OCTOBER 12, 2006  
PLANNING COMMISSION MEETING  
AGENDA

Project &  
 Applicant: Dennis Recknor  
 Address: 2001 Yorkshire Ave.  
 (06058.06a)

## Planning Commission Staff Report Meeting of October 12, 2006

Sheet Title: **GRADING PLAN**

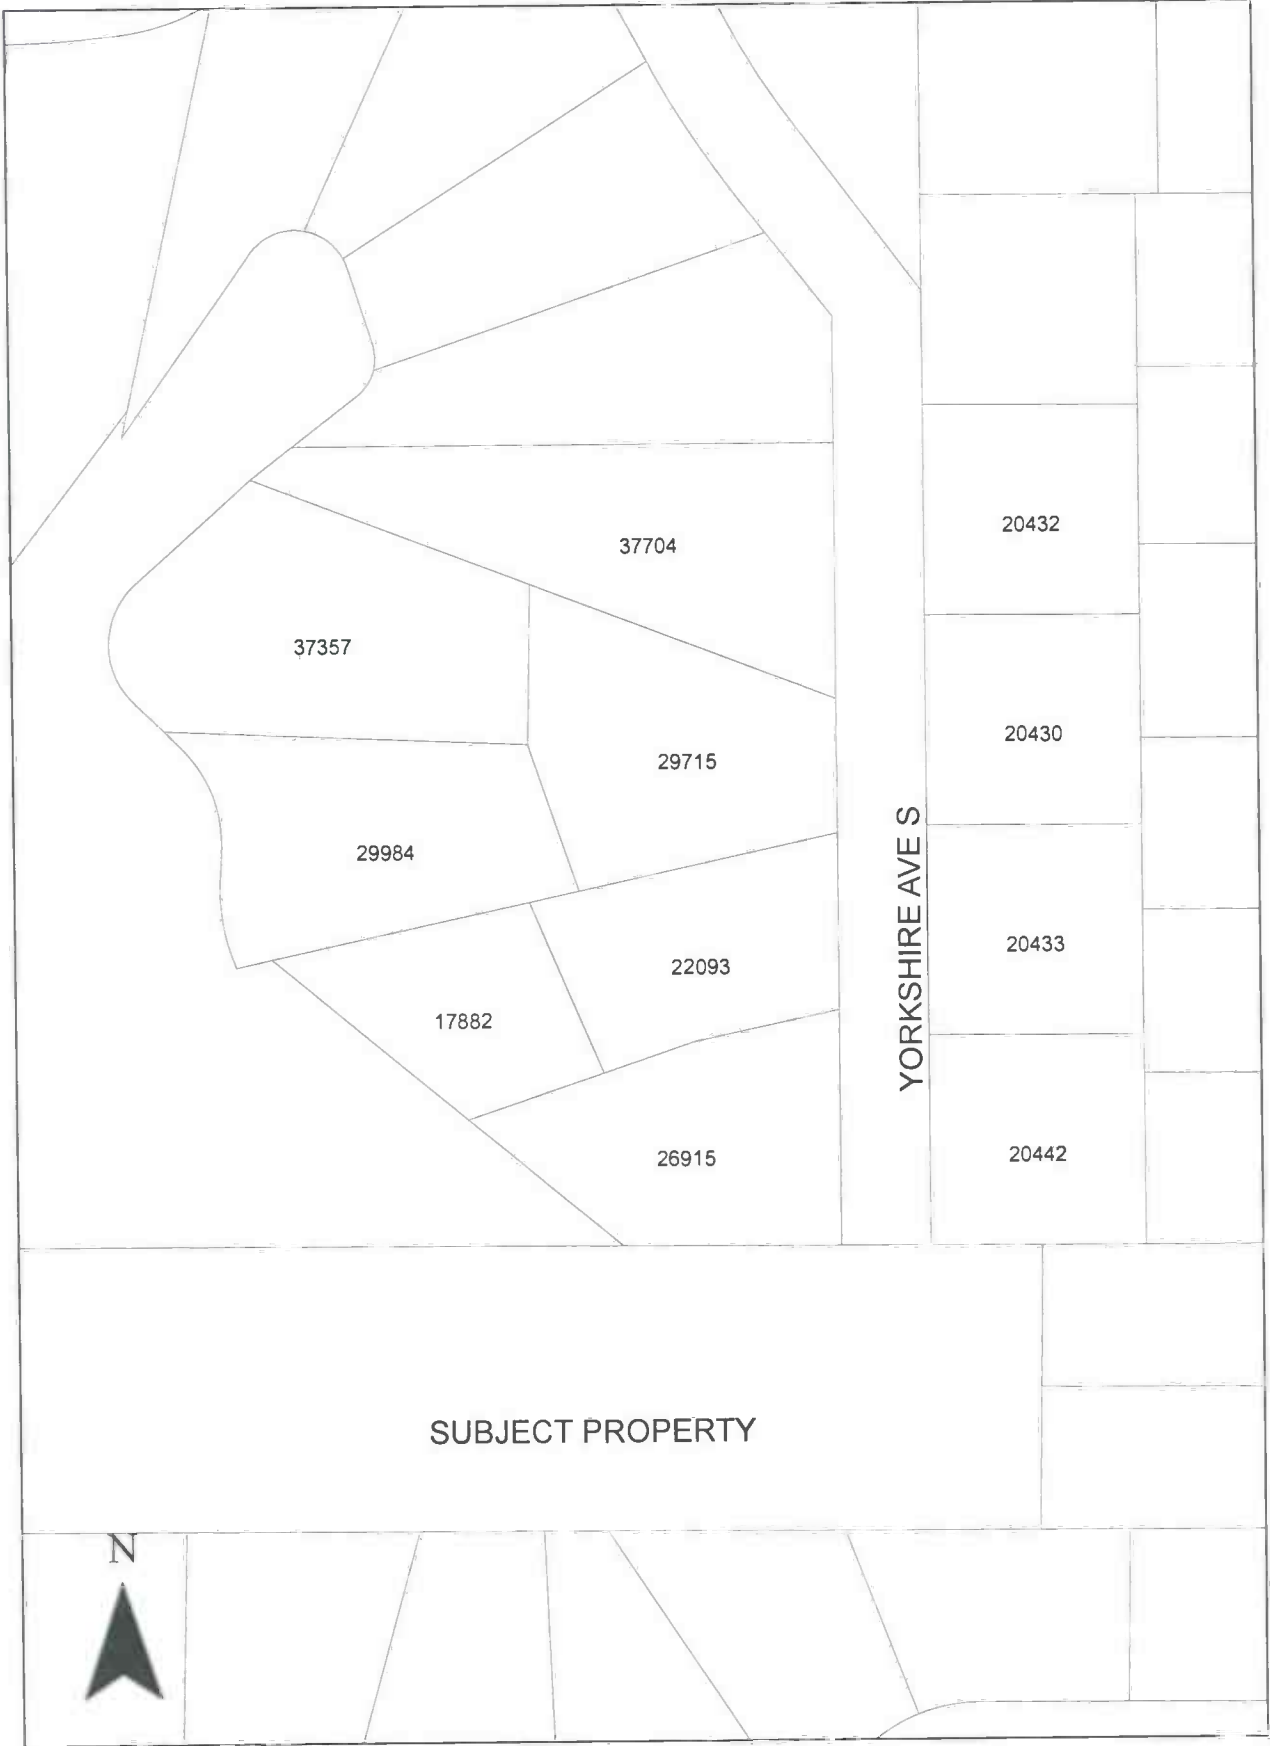
**3. Wetland barrier and drainage concerns.** House #1 on the grading plat looks like it may not be far enough from the lake and wetland delineation as well as the floodplain. Additionally, in order to give this house a flat foundation (as the area now slopes downward), much fill dirt will need to be added that would raise this house well above the side of our house that it would border, putting us at risk for flooding. This has happened at the subdivision two houses down from us, where two very large houses were built in this neighborhood of older, modest homes. The drainage from the much-higher new homesite floods the neighbors' drive and yard regularly. Another recently-built large home next to us (at 1914 Yorkshire) drains into our back yard.

**4. Trees.** The Grading Plan page appears to have some text on the far right side referring to treatment of trees on the lot. This was cut off in the materials we received, but we would be very interested in seeing the proposals in this regard. There are many lovely old trees on this lot, including old oaks, which are in jeopardy.
